Title: **DMURS Quality Audit Including Stage 1&2 Road Safety
Audit for;**

Parkway Valley LRD, Dublin Road, Limerick.

Client: **Kirkland Developments Ltd.**

Report reference: **2948R01**

4.1 Problem

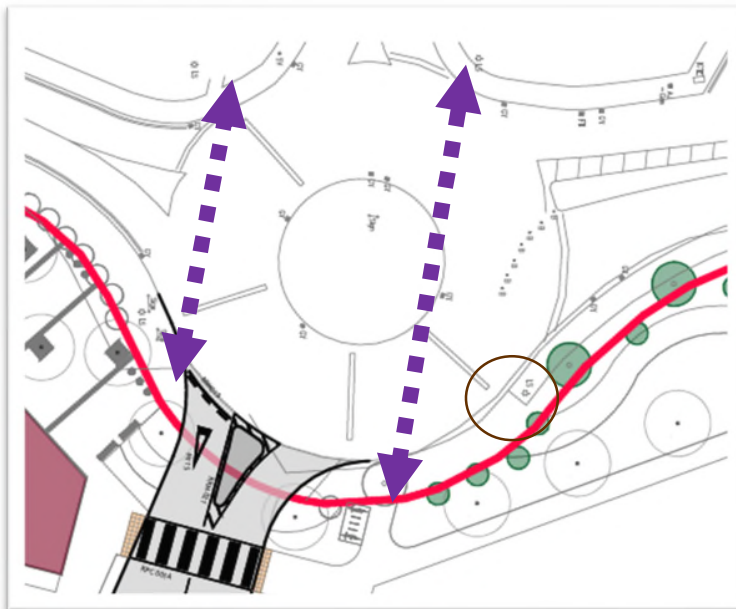
The proposed development will result in a pedestrian desire line to cross the existing northern and southern arms of the roundabout to go to and from the Retail Park. There are currently no crossing facilities and the footpath on the eastern side of the access road stops prior to the new access to the development. A lack of crossing facilities could lead to pedestrians crossing at inappropriate locations leading to collisions with vehicular traffic.

It is recommended that crossing facilities and continuous footpaths be provided.

4.2 Problem

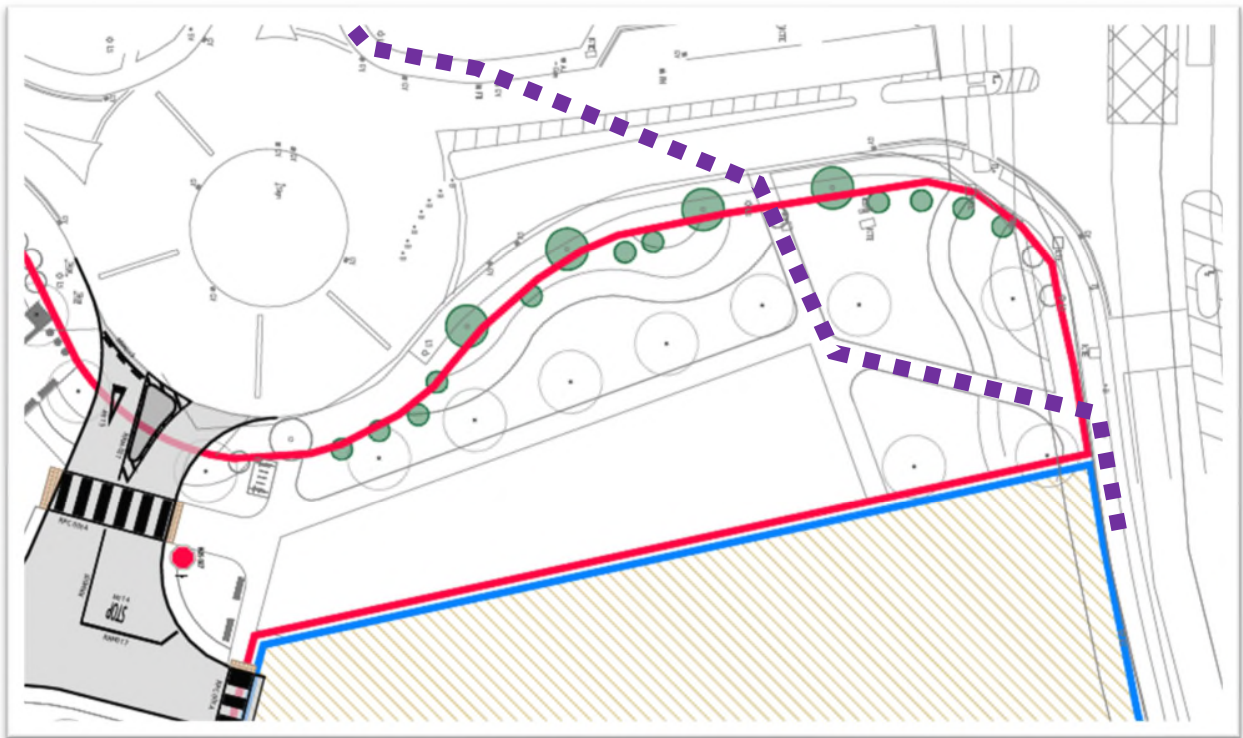
The proposed development's open space close to the R445 will lead to a pedestrian desire line to cross the access road to the Retail Park. There are currently no crossing facilities except at the signalised junction and a small gap in the central concrete island which are not along the desire line. A lack of crossing facilities could lead to pedestrians crossing at inappropriate locations leading to collisions with vehicular traffic or trips and falls on the high kerbs.

It is recommended that a crossing for pedestrians be provided that meets with the desire line.

4.3 Problem

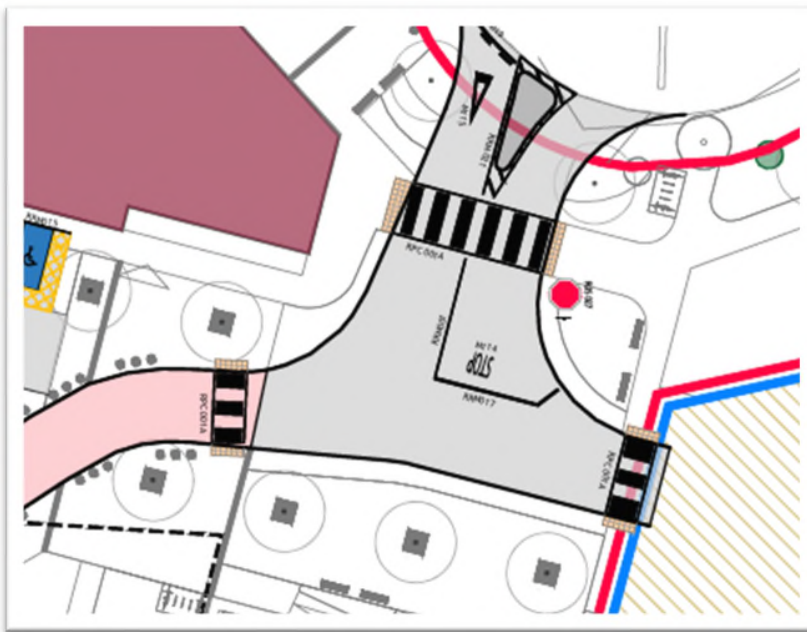
There are a number of uncontrolled pedestrian crossings within the proposed development that are shown to have zebra crossing stripes however there is no signage proposed and the tactile paving suggests that that pedestrians do not have priority. The lack of clarity over the type of crossing could lead to confusion between pedestrians and drivers over priority, resulting in collisions.

It is recommended that zebra crossing be provided along with appropriate signage and road markings and be raised as per the requirements of the Traffic Signs Manual. Crossing specific lighting should also be provided. The crossing widths should reflect the expected demand (It is noted that 2m crossing is shown in some standard details and this may not be wide enough).

QA incl St 1-2 RSA, Parkway Valley LRD**Kirkland Developments Ltd****4.4 Problem***LOCATION*

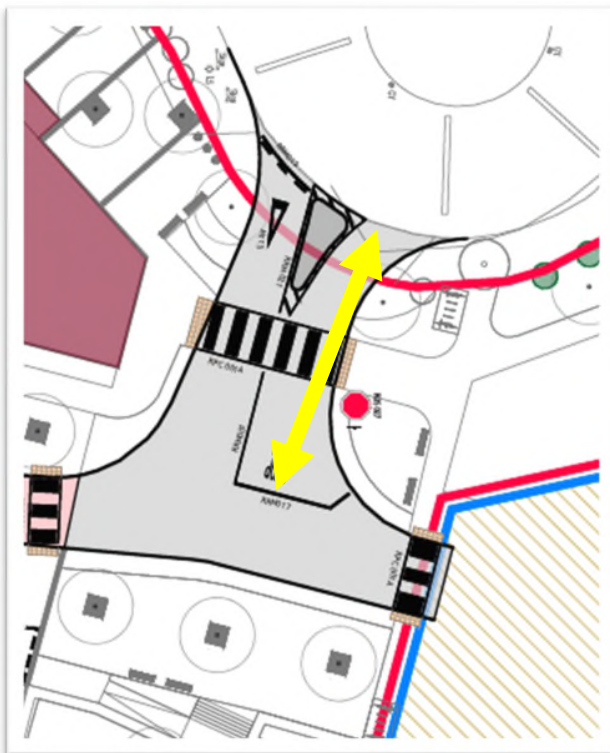
There is a proposed stop line on the internal road very shortly after the exit from the retail park roundabout. There is a risk that at peak times (especially when Street 1 is extended in future to the north) that this will lead to queuing onto the circulating carriageway of the roundabout and result in rear-end collisions.

It is recommended that the capacity be assessed to ensure that queuing onto the roundabout does not occur. If it may occur then the priority should be changed at the internal street junction.

4.6 Problem

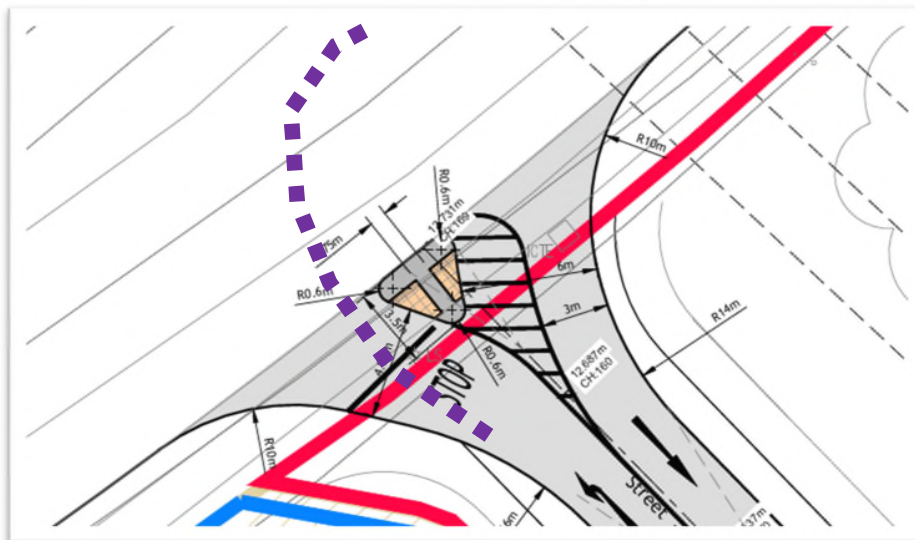
The R445 is not a divided road. There is a risk that drivers will turn right at the junction to avoid delays at the traffic signals of the Retail Park junction and at the Parkway Roundabout or the Retail Park roundabout if they wish to travel east. This could lead to collisions with vehicles in any of the 4 traffic lanes.

It is recommended that a physical island be provided in the centre of the R445.

4.7 Problem

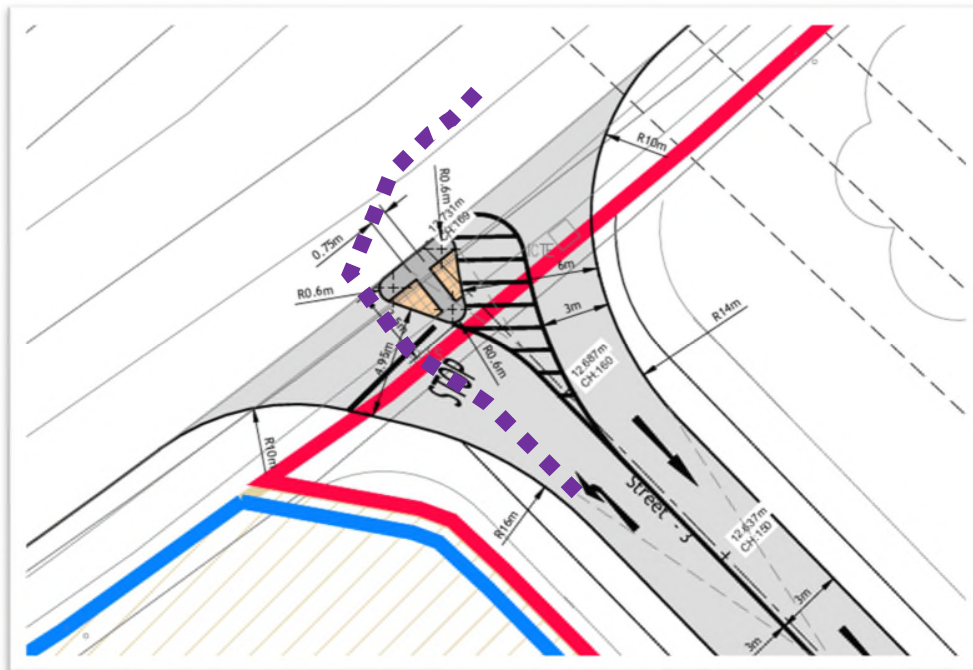
There is a risk that some drivers may inadvertently turn right onto the R445 into a westbound lane leading to head-on collisions.

It is recommended that signage indicating ‘no right turn’ and ‘turn left’ be provided and that the shape of the splitter island be such that drivers would find it physically difficult to turn right.

4.9 Problem

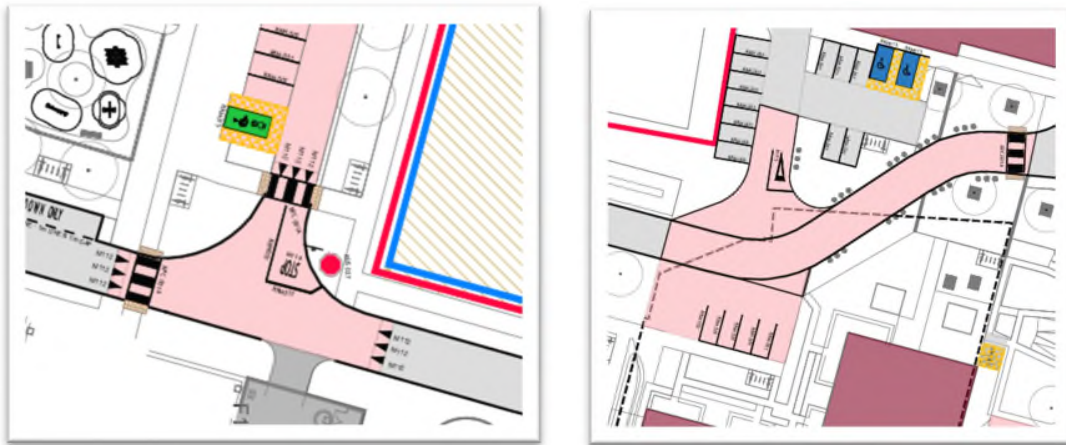
There are some street areas with coloured surfacing. It is not clear what the change in colour signifies and what message it is trying to convey to drivers and other road users. There is a risk that these areas are intended to be shared use streets however there is no indication that this is the case and the first area close to the roundabout will be a heavily traffic section.

It is recommended that shared use streets are only provided in cul-de-sacs and that they do not extend into the main carriageway.

QA incl St 1-2 RSA, Parkway Valley LRD**Kirkland Developments Ltd****4.10 Problem***LOCATION*

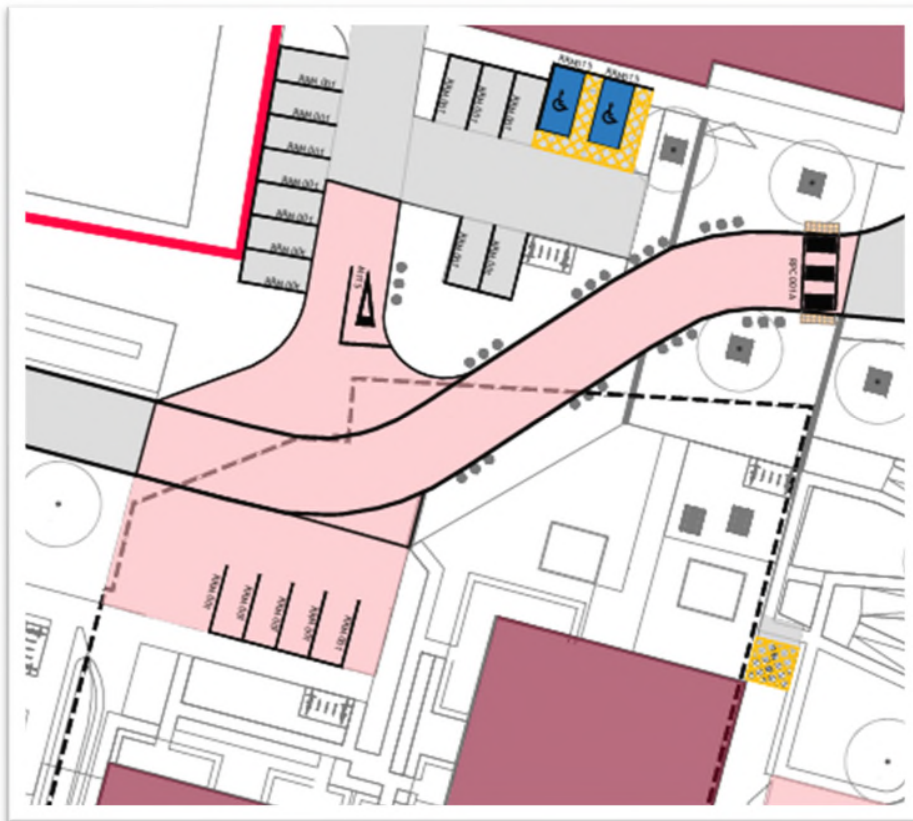
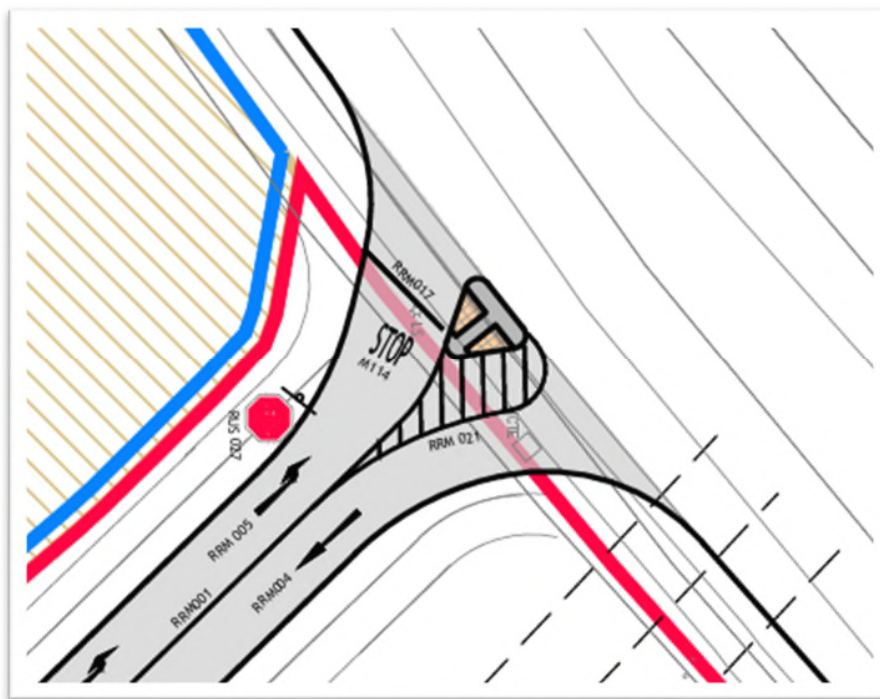
There junction mouth to the parking at the medical centre is very wide. This could lead to high turning speeds and in turn high severity injuries if a vulnerable road user is struck.

It is recommended that the corner radii be reduced and if required an over-run area be provided for delivery/refuse vehicles. The yield control should be changed to a stop control and the stop line set a suitable distance back from the carriageway edge.

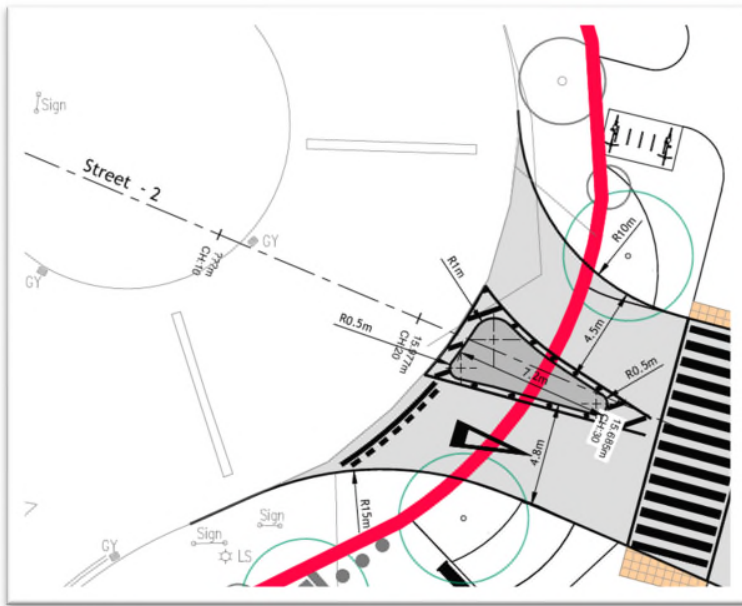
There Li-Lo junction gives high priority to vehicular traffic and there are wide areas for pedestrians to cross with a small refuge area at the splitter island. There is a risk that drivers exiting the development will be focused on gaps in traffic and will not check for crossing pedestrians or cyclists. This could lead to collisions with those vulnerable road users.

It is recommended that higher priority be given to pedestrians by having a raised crossing with a larger refuge area. The stop line should be set back behind the raised crossing.

5.2 Issue

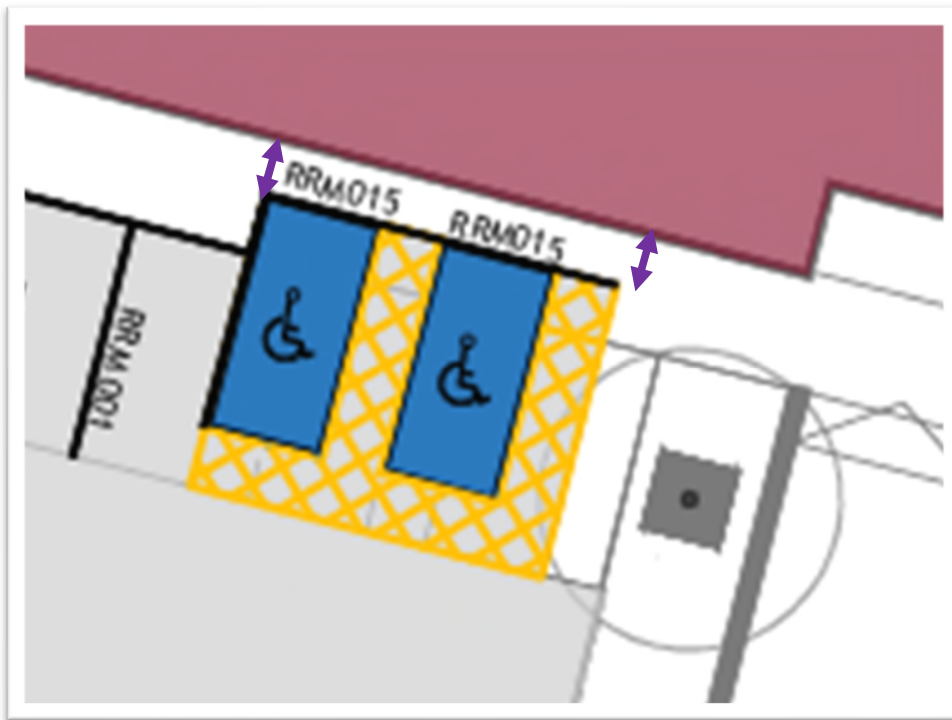
There is a risk that the disabled parking spaces adjacent to the building will leave a footpath of insufficient effective width for pedestrians, especially the mobility impaired to pass.

It is recommended that sufficient space be provided taking into account the proposed usage of this building.

QA incl St 1-2 RSA, Parkway Valley LRD**Kirkland Developments Ltd****5.4 Issue***LOCATION*

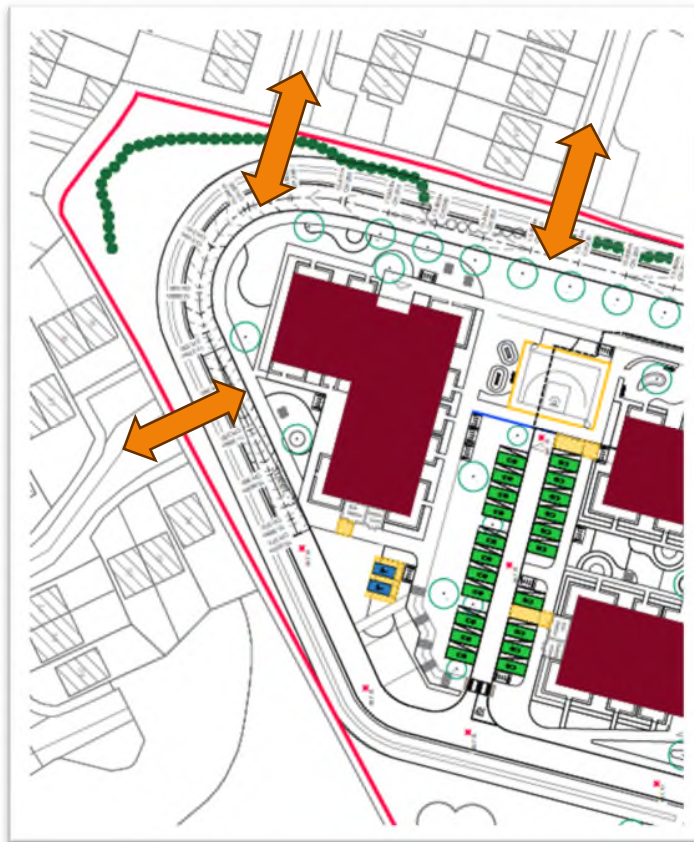
There are no proposed links to the neighbouring residential developments for pedestrians or cyclists. A lack of permeability could lead to informal links that are not safe, especially given the topography of the site.

It is recommended that an assessment of the benefits of permeability links be carried out and that they be provided, if appropriate.

6.1 Issue

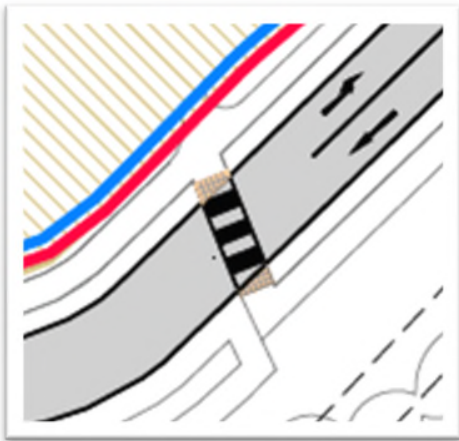
A skewed pedestrian crossing is shown on the R445 access road. These can be difficult for drivers to judge where to stop and for blind or partially sighted pedestrians to judge where to cross.

It is recommended that a perpendicular crossing be provided.

7.1 Issue

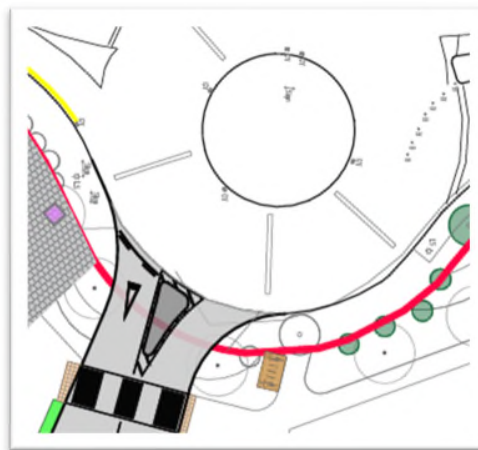
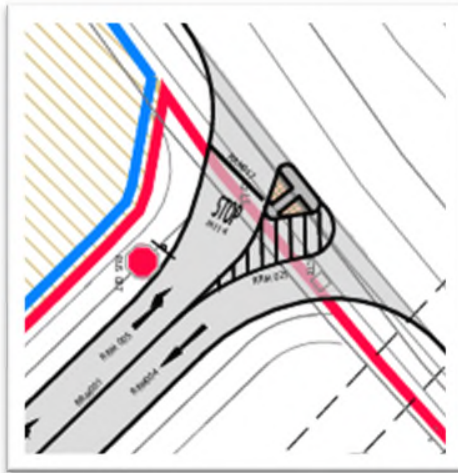
Cyclists were observed using the footpath along the R445 as there are no dedicated cycle facilities except at the immediate approach to the signalised junction for the Retail Park. There are also no dedicated cycle facilities proposed for access to the development. The roundabout access can be difficult for cyclists given the high number of potential conflict points and the Li-Lo junction may lead to drivers turning left and not seeing cyclists in their blind spots.

It is recommended that transition facilities be provided for cyclists to get into the quieter development streets from the external road network.
